TO: Mercedes-Benz Principals, General Managers, Sales Managers, Service Managers, Parts Managers	FROM: Anthony Washington, Department Manager, Regulations and Certifications
<b>Re: Recall Campaign Launch Notification</b> <b>Model 907 (Sprinter)</b> <b>Model Years 2019-2021</b> <b>Inspect Swivel Seat Wiring Harness Routing</b>	DATE: August, 2021

<b>Campaign No. :</b>	<b>Campaign Desc. :</b>	Inspect Swivel Seat Wiring Harness Routing
<b>2021070031</b>	<b>VS3DREHSEL</b>	
<p>This is to notify you of a <b>Recall Campaign Launch</b> to inspect the swivel seat wiring harness routing on approximately <b>3,847</b> MY19-21 Mercedes-Benz Sprinter vans. The recall campaign will be visible on the <a href="http://www.safercar.gov">www.safercar.gov</a> website and may generate questions from customers. All affected VINs will be flagged as <b>"OPEN"</b> in VMI and cannot be sold until remedied.</p>		
<b>Background</b>		
<b>Issue</b>	<p>Mercedes-Benz AG ("MBAG"), the manufacturer of Mercedes-Benz has determined that on certain Freightliner Sprinter vehicles of Platform 907 (VS30) that are equipped with electrically adjustable front swivel-seats, the seat wiring harness might be improperly routed o

D91.10-A026-76

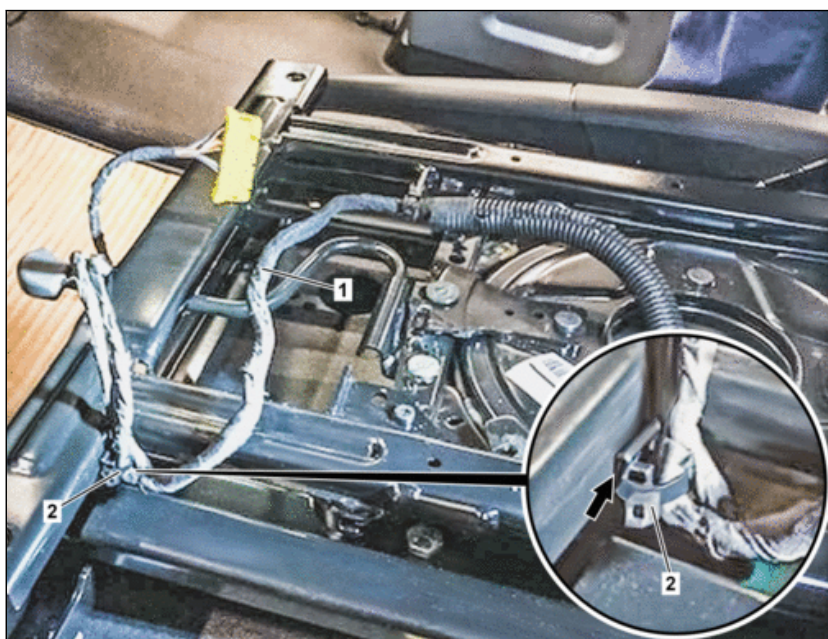
**Shown on driver's seat with code SF1 (Electrically adjustable driver's seat) and code SR8 (Driver's seat rotating frame)**

- 1 Wiring harness
- 2 Cable tie with retaining clip

3	Subsequently adapt line installation and attachment of wiring harness (1) to respective rotating seat.	<p><b>i</b></p> <p>To do so, check if the wiring harness (1) is correctly fastened to the respective rotating seat frame using a cable tie with retaining clip (2).</p> <p>The wiring harness (1) must be positioned in the corner (arrow) of the rotating seat frame, as shown in the picture, and fixed in place using a cable tie with retaining clip (2).</p> <p>If cable tie with retaining clip (2) is not present,</p> <p style="text-align: center;">↓</p> <p>subsequently fasten wiring harness (1) to rotating seat frame using retaining clip (2). To do so, position wiring harness (1) along cable tie with retaining clip (2) in corner (arrow) of rotating seat frame. See figure.</p> <p>If cable tie with retaining clip (2) is present,</p> <p style="text-align: center;">↓</p> <p>position wiring harness (1) correctly on rotating seat frame. To do so, position wiring harness (1) along cable tie with retaining clip (2) in corner (arrow) of rotating seat frame. See figure.</p>

D91.10-A027-82

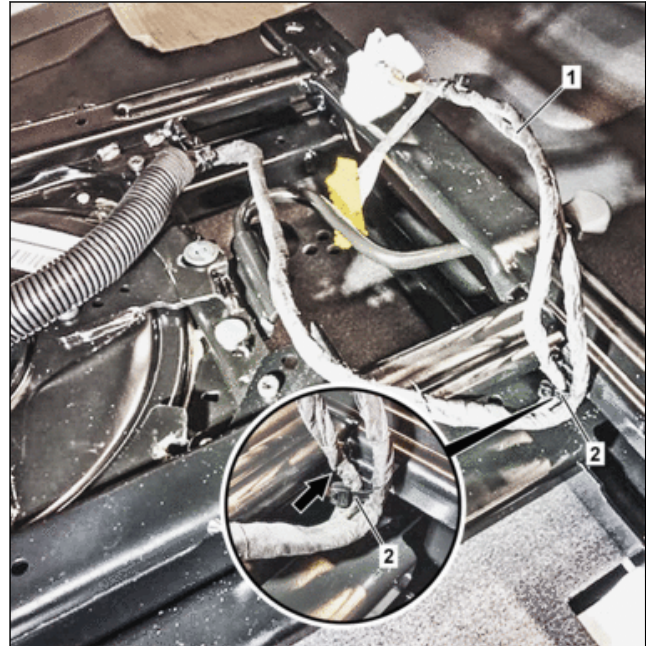
Shown on driver's seat with code SF2 (Electrically adjustable front passenger seat) and code SR9 (Front passenger seat rotating frame)

- 1 Wiring harness
- 2 Cable tie with retaining clip

If rotating seats are installed on the driver and passenger side, then the line installation of both rotating seats must be checked and adapted, if necessary.
